**PLANT SPECIFIC SEISMIC ADEQUACY  
EVALUATION OF TURKEY POINT  
UNITS 3 AND 4 TO RESOLVE  
UNRESOLVED SAFETY ISSUE (USI) A-46  
AND GENERIC LETTER (GL) 87-02**

Final Report

April 30, 1993

Florida Power & Light  
P.O. Box 14000  
Juno Beach, FL 33408

BATTERY CHARGE - 4A

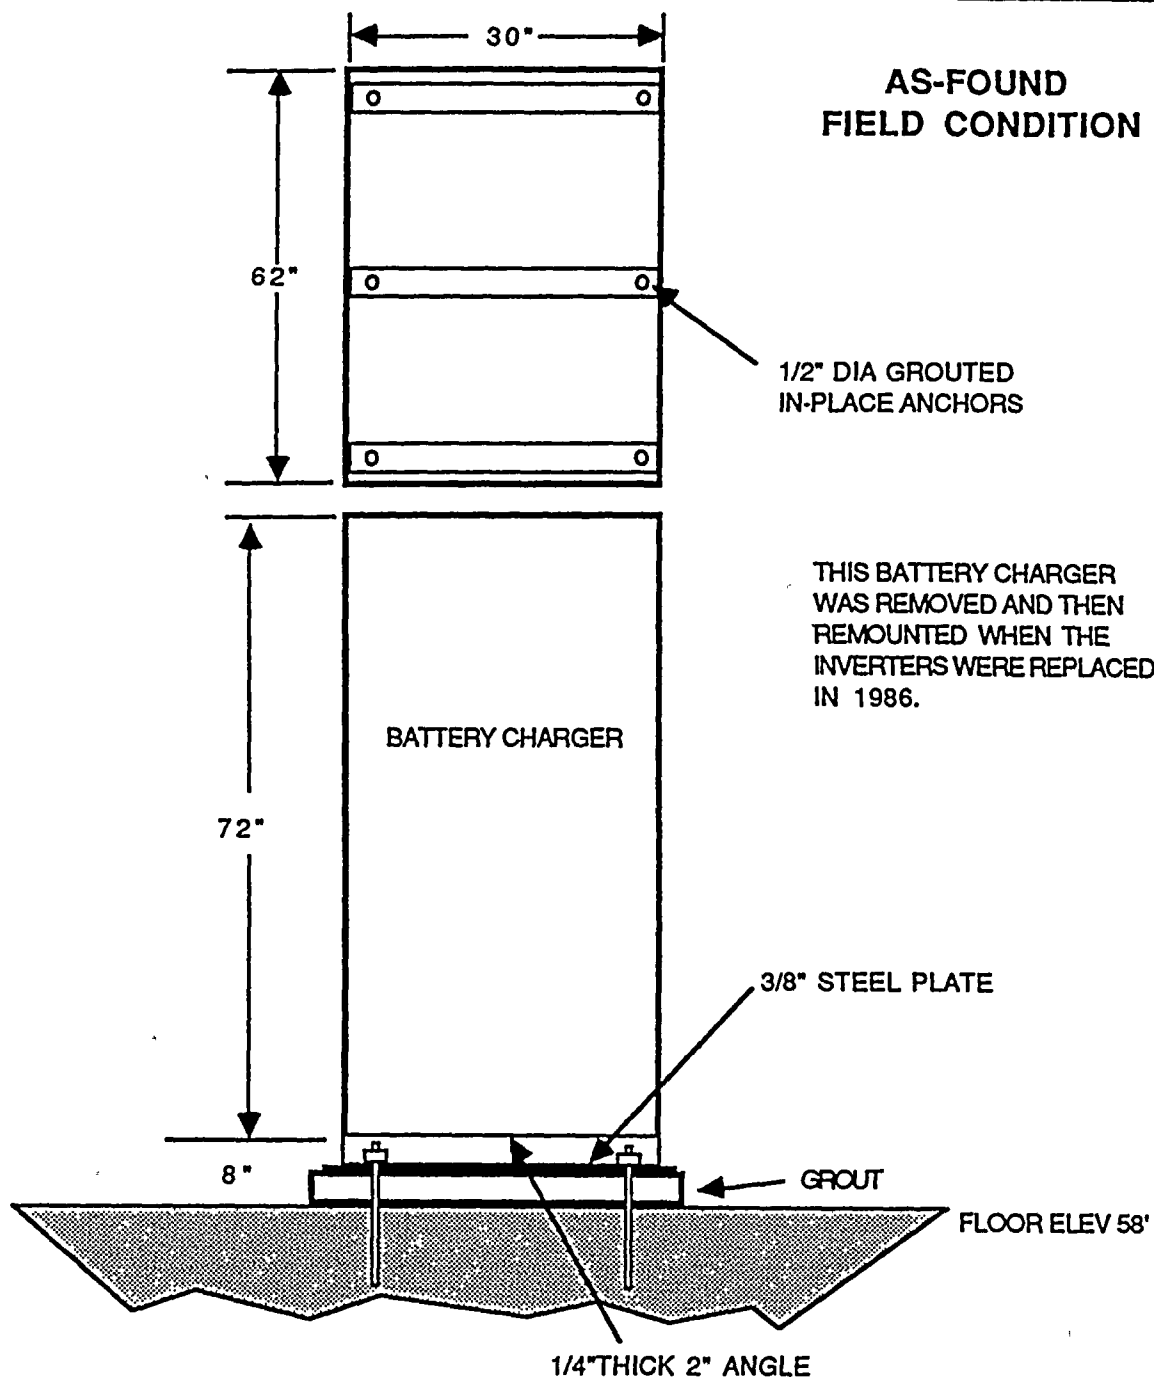
SRT REQUESTED A BOUNDING CALCULATION  
AND REVIEW OF THE BOUNDING CALCULATION  
INDICATED ADEQUATE ANCHORAGE.

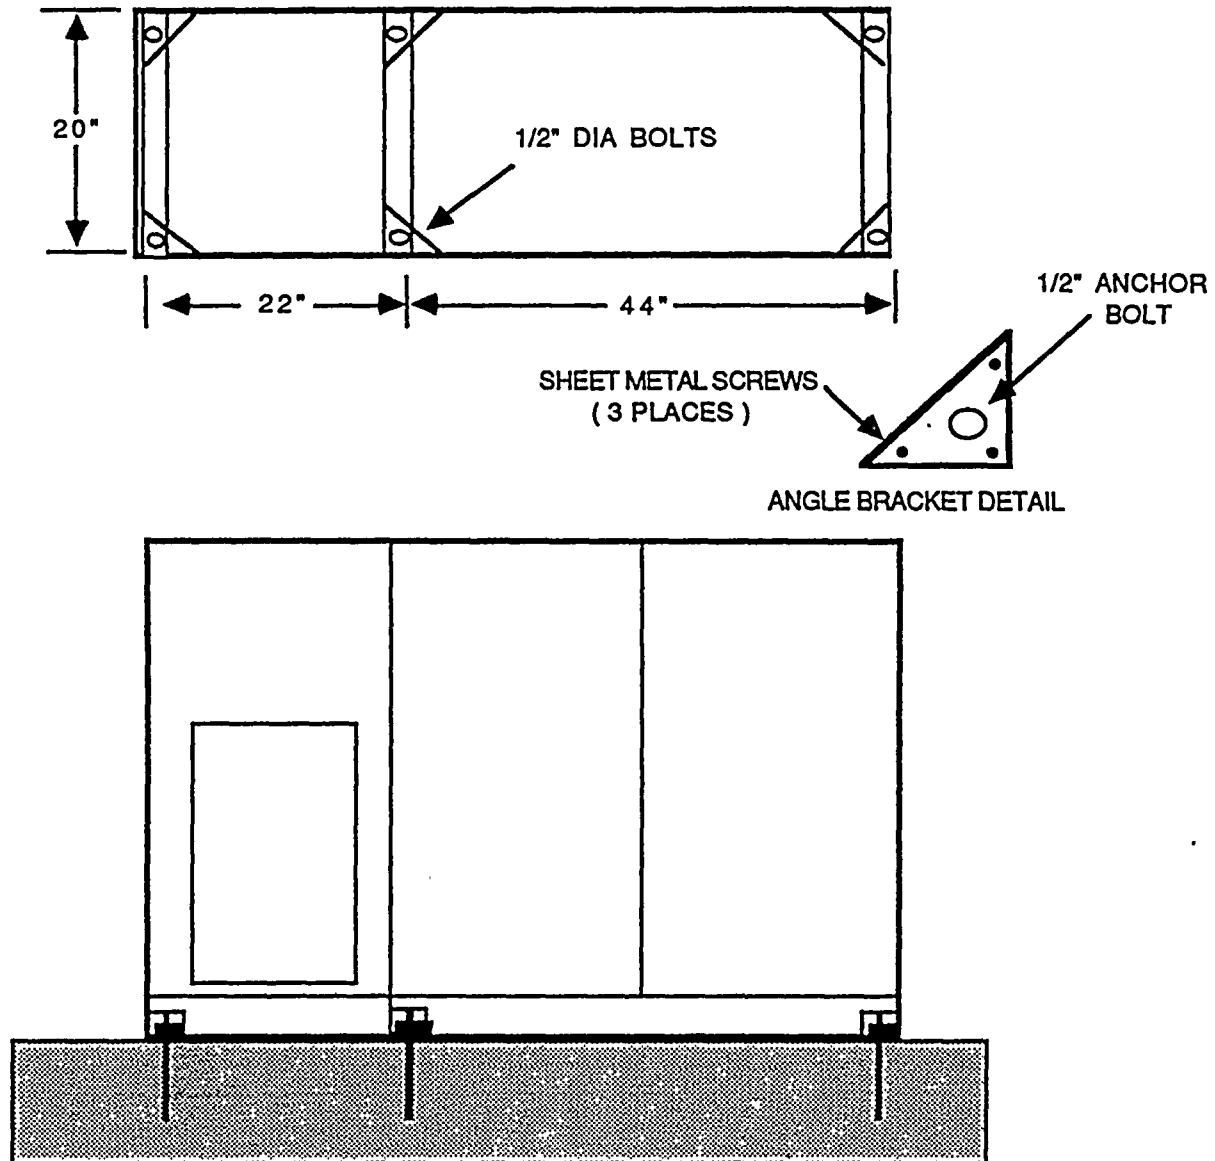
THE SRT NOTED THAT SHEET METAL BRACKETS WILL BE THE CONTROLLING FACTOR FOR ANCHORAGE OF THIS BUS

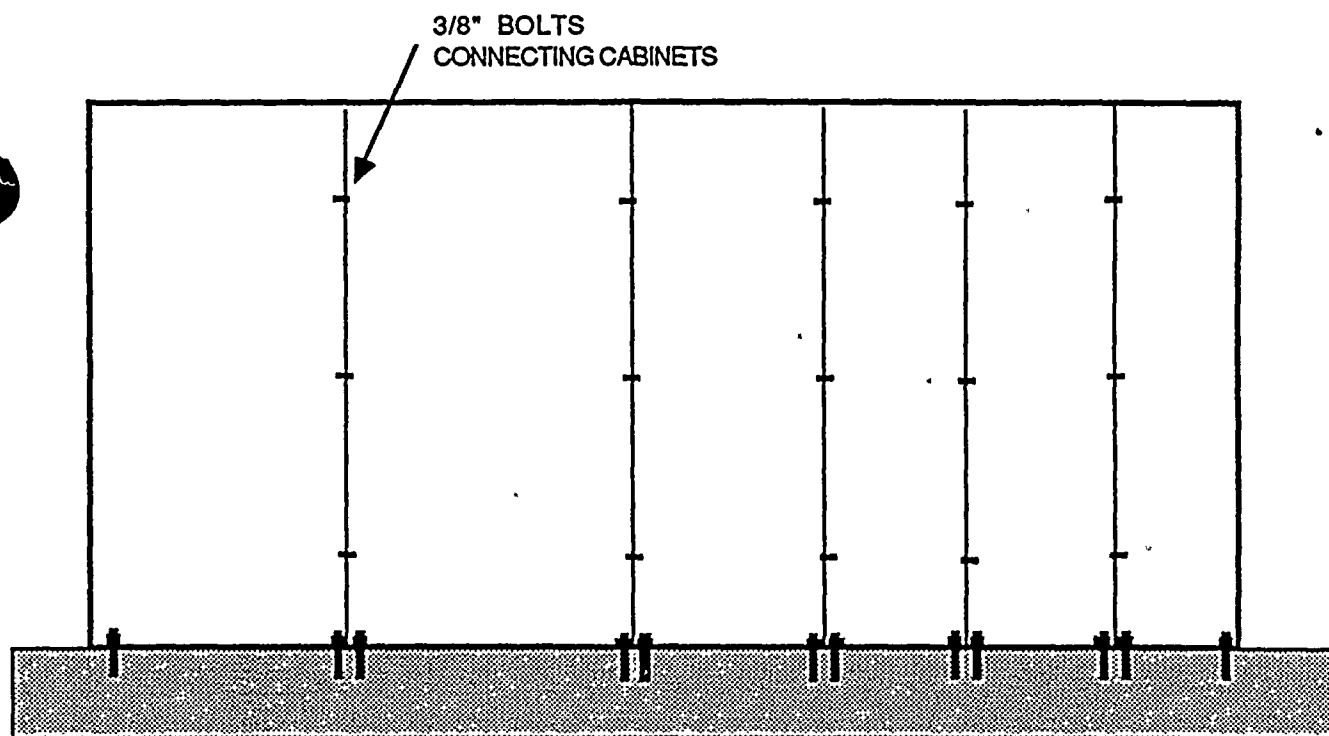
THE SRT REVIEWED THE PREVIOUS  
PANEL CALCULATIONS AND ACCEPTED  
THE ANCHORAGE DESIGN.

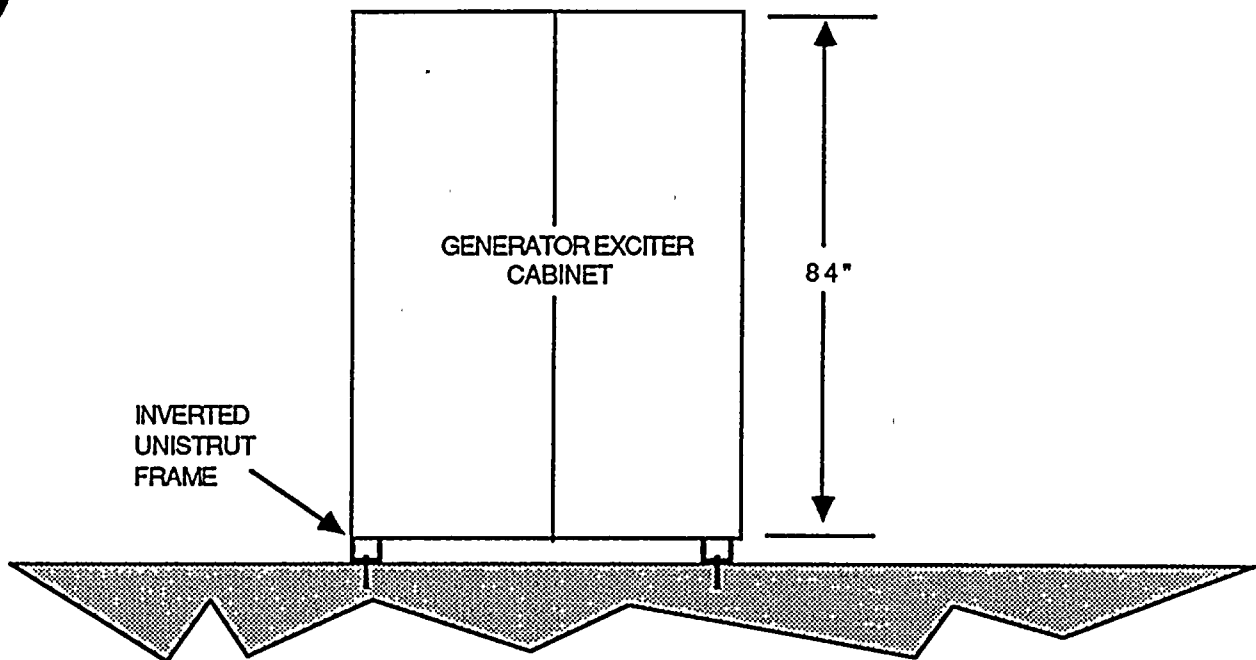
THE SRT REQUESTED AN OVERTURN  
CALCULATION FOR THIS CABINET. THE  
REVIEW OF THE CALCULATION DETERMINED  
THAT THE CABINET WAS ADEQUATELY  
ANCHORED.
